**IN THE MATTER OF: Notice of Requirement for
the Designation of Pinehaven Stream (UHC-92).**

STATEMENT OF EVIDENCE

James Gary Beban

Figure 4-9 100-year ARI long-section

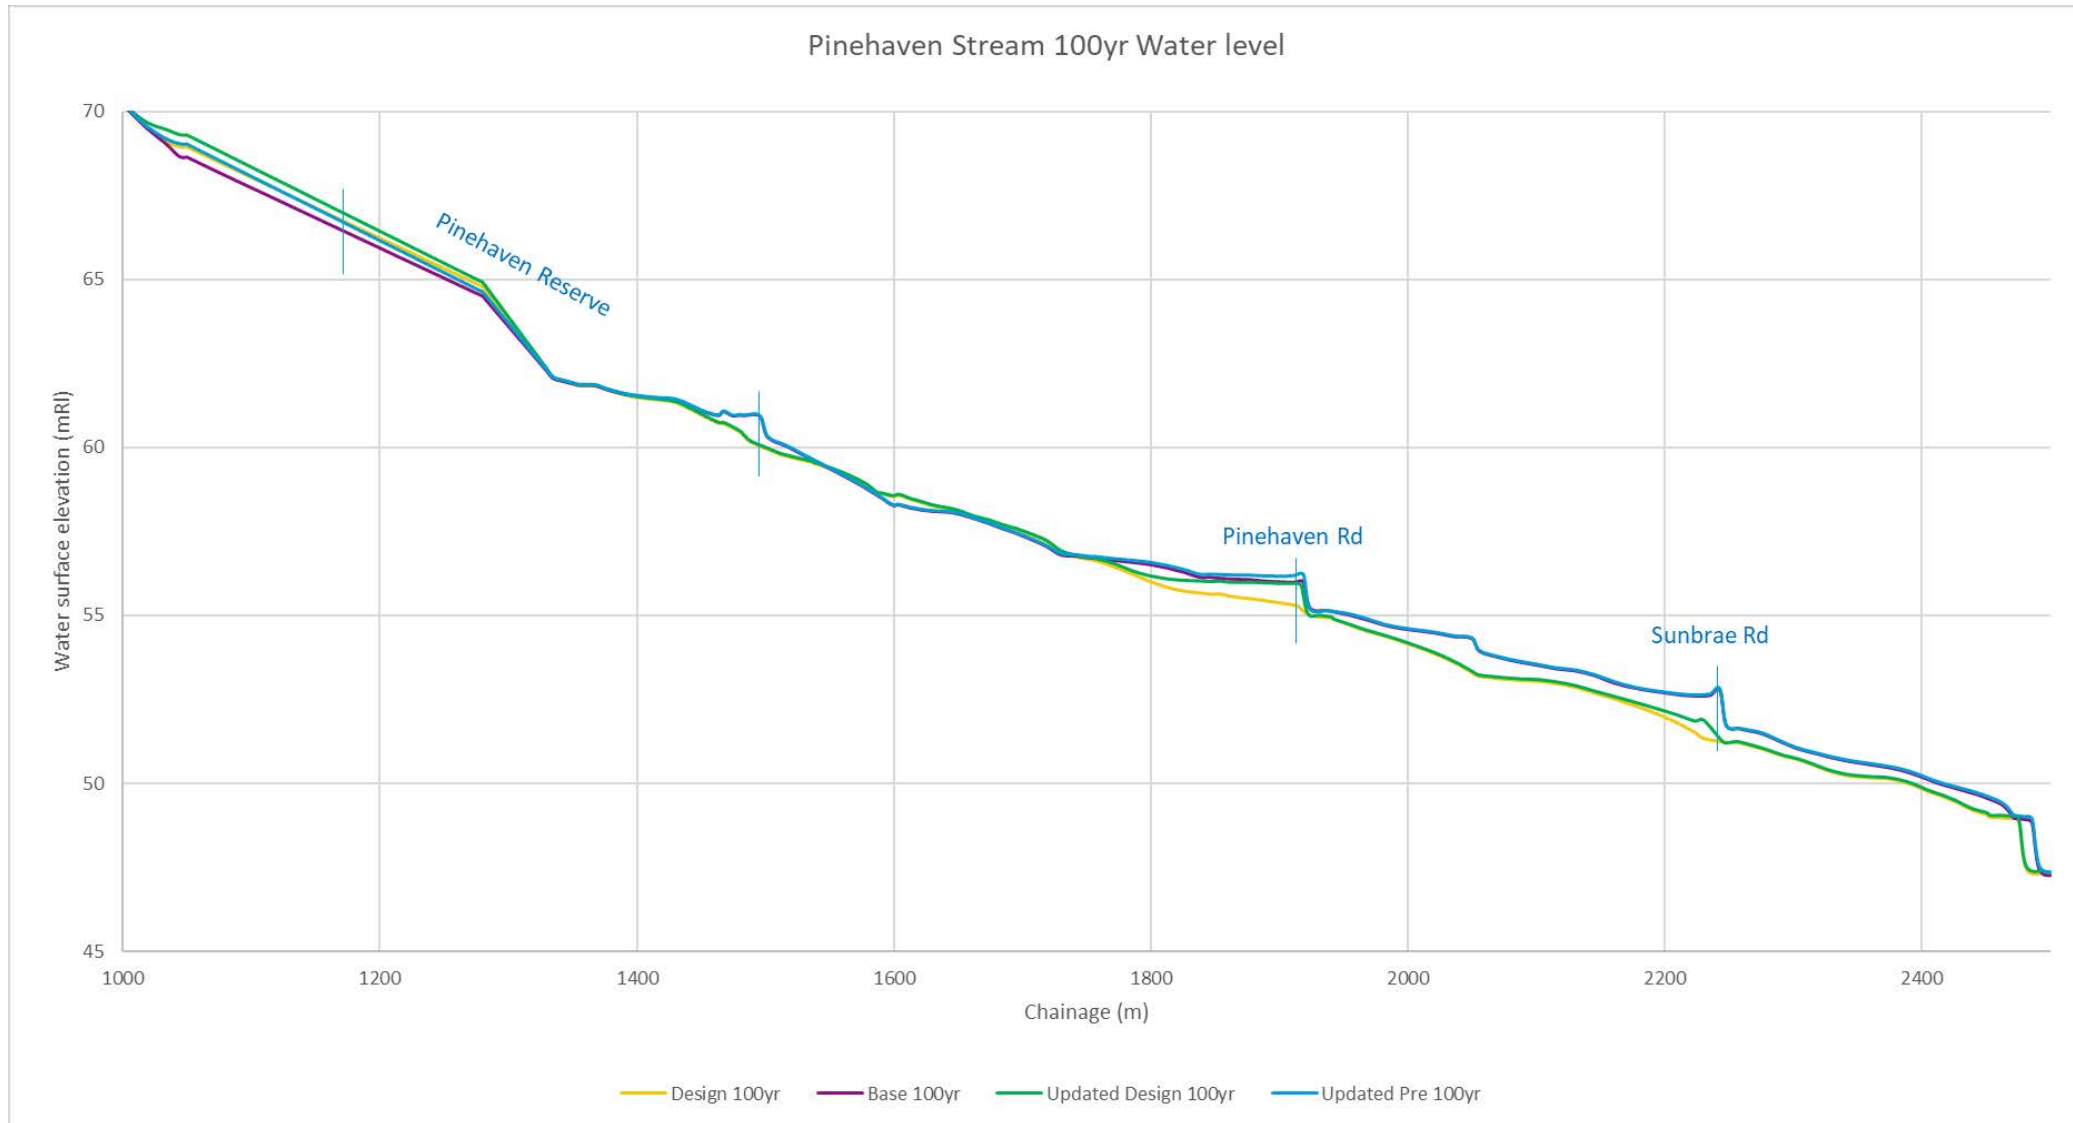
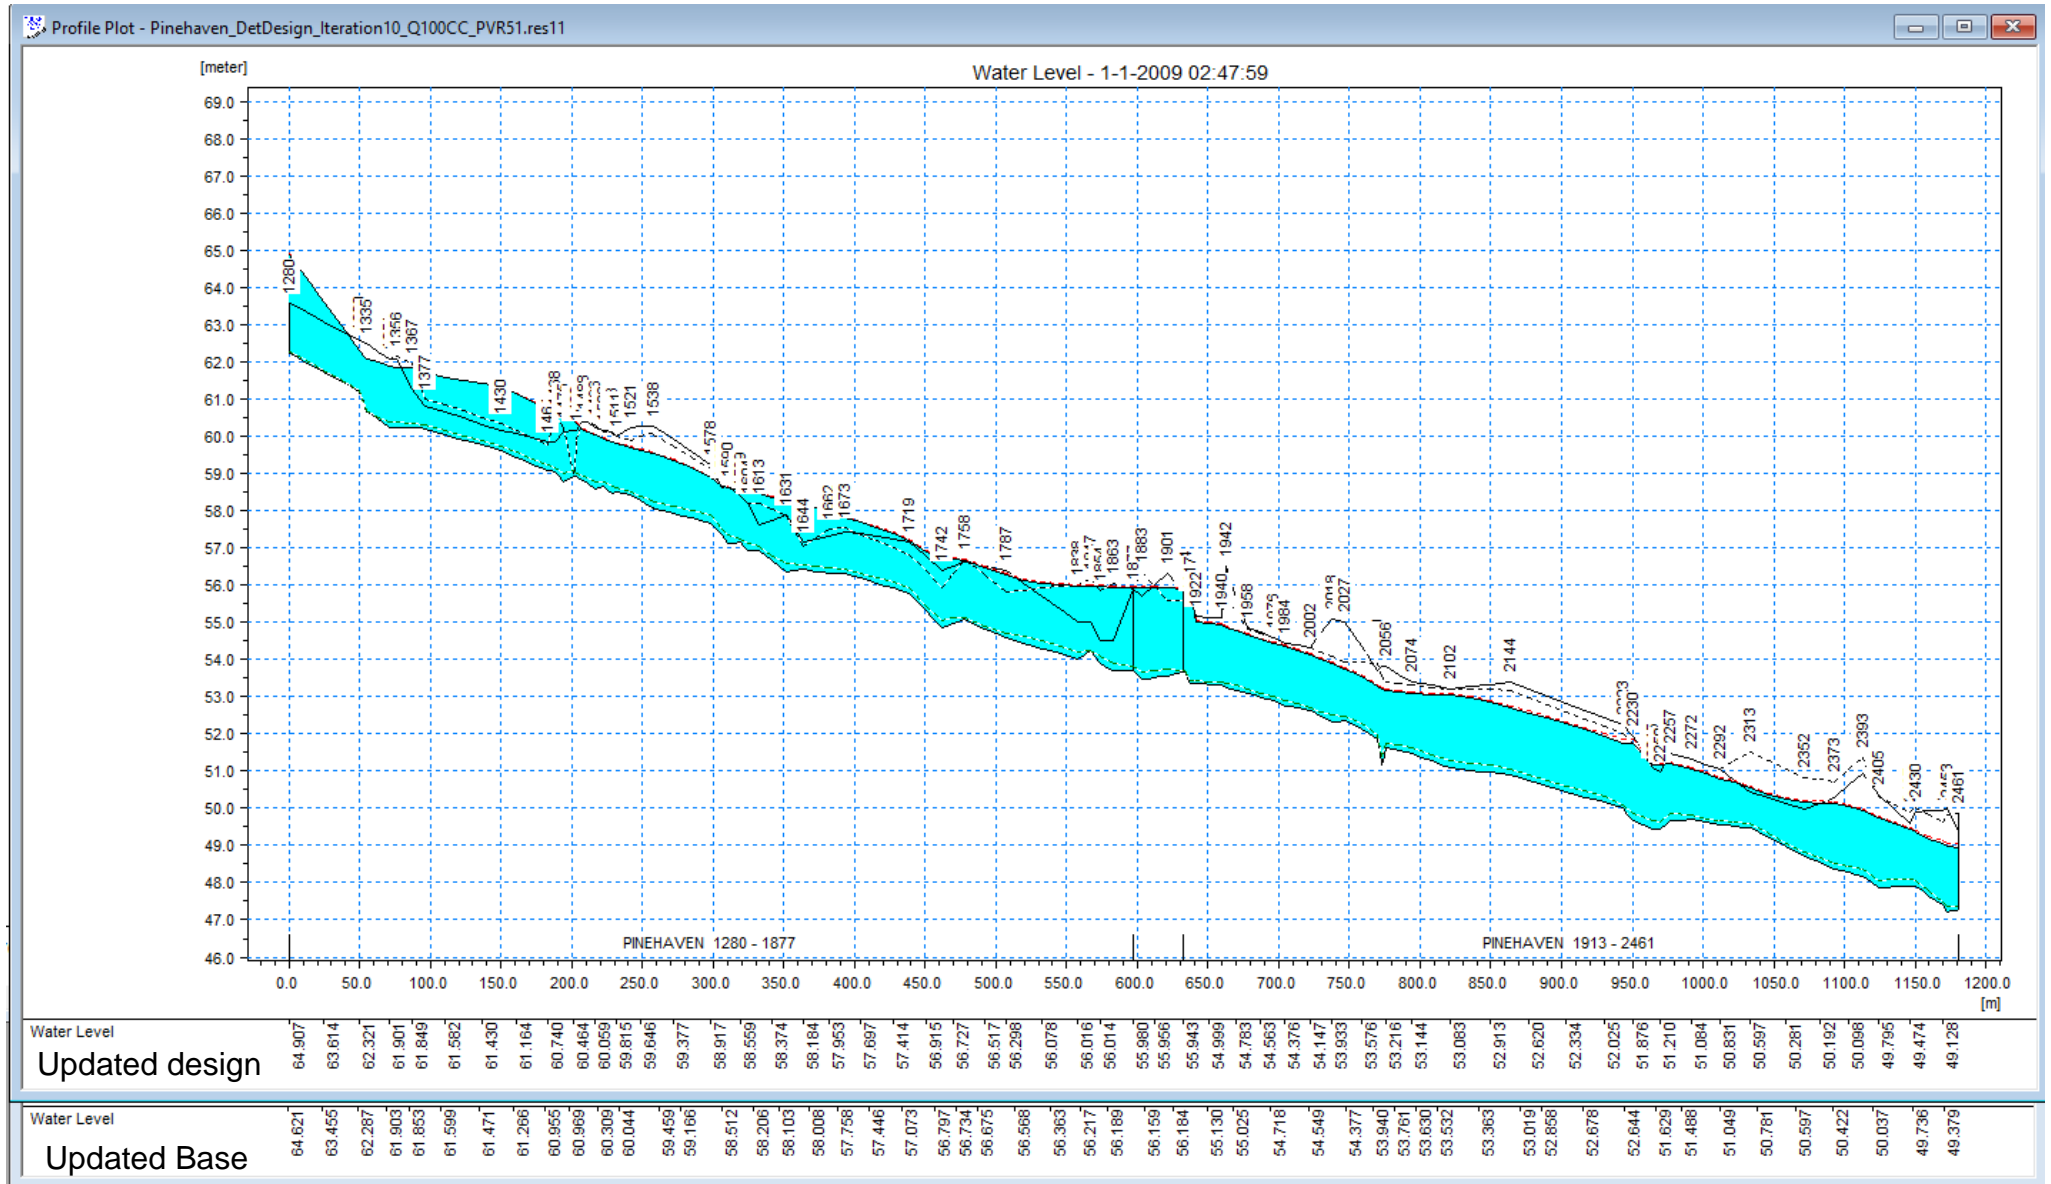
Update June 2020 Both culverts (Sunbrae Drive and Pinehaven Road) have had a reduction in width to account for blockage.		CLOSED	0	Yes
MIKE11 Water levels	<p>The HGL plot in Figure 4-9 and Figure 4-10 shows that the 100-year ARI event water levels are reduced in most stretches of the stream due to the stream widening and larger culverts. Two sections have increased in water level.</p> <ul style="list-style-type: none"> The piped section in and upstream of Pinehaven Reserve. This is unexpected, as we assumed that there were no changes in this reach and do not expect it to be affected by the stream works. <u>Is the modeller able to explain this?</u> A short section at Ch.1600. Near 2A Freemans Way (as stated in the executive summary of the Flood Hazard Assessment report) 	<p>The piped section in Pinehaven Reserve was not checked because it is outside the area of main channel works. Differences in water level do not affect containment within the channel (as this is a piped section) or habitable floor flooding (as the area is a reserve).</p> <p>Near 2A Freemans Way there are no channel works proposed. The differences are thought to be due to a combination of channel works upstream directing more flow into this reach instead of entering the Birch Grove area and a slight change in timing of the flood peak.</p>	<p>Uncertainty over the cause of the raised water levels through the reserve is not expected to adversely affect the relative effects of the stream works, and so does not materially affect the 'fit for use' categorisation.</p> <p>However, the Reviewer notes that the issue is not resolved and so the issue will remain open</p> <p>OPEN (see June 2020 update)</p>	2	Yes

Item Checked	Findings & Comments	Modeller's response	Reviewer close out comments	Rating	Fit for use
MIKE11 Water levels continued	<p>Update June 2020</p> <ul style="list-style-type: none"> Water levels have again increased in the piped section but as agreed not likely to effect water levels in the area for the proposed works <p>The HGL plot shows some minor difference from the last design iteration- Increase in water level at CH.1917, this seems to be the effect of the blockage</p>		CLOSED	1	Yes
MIKE21	<p>Downstream of Pinehaven reserve there is a significant reduction in flood levels. These are replicated in both the M11 water levels and the M21 results (Figure 4-11).</p>	Noted; agreement with comment.	CLOSED	0	Yes
	<p>Update June 2020</p> <p>Figure 4-11 shows an increase in flood depth (as noted in the Flood Hazard Assessment) around 48-50 Blue Mountain Rd. Other than that, the difference shows a general reduction in flood depth. Dark Blue areas are areas that flood in the current (base) model and don't in the Design model. See comment regarding this issue in the Flood Hazard Assessment review.</p>		CLOSED	1	Yes

Figure 1: Reported Crashes from NZTA Crash Database

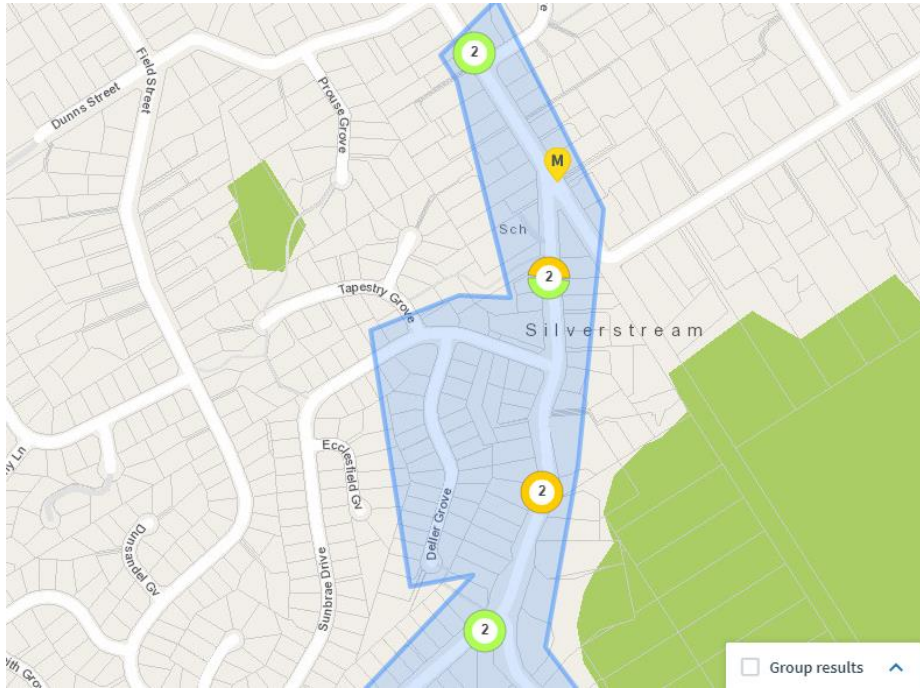
The assessment does not include any analysis of the local road safety record, the local speed environment, the availability of footpaths and the forward sight lines along the main route.

Four of these crashes involved single vehicle incidents with loss of control either as a result of turning or being positioned too far left. Crash factors for three of the other crashes included cutting corner on the bend, speed entering corner/ curve and too far left. The CTMP will need to include allowance for further restrictions to forward sight lines as a result of construction related obstructions either within or adjacent to the carriageway.
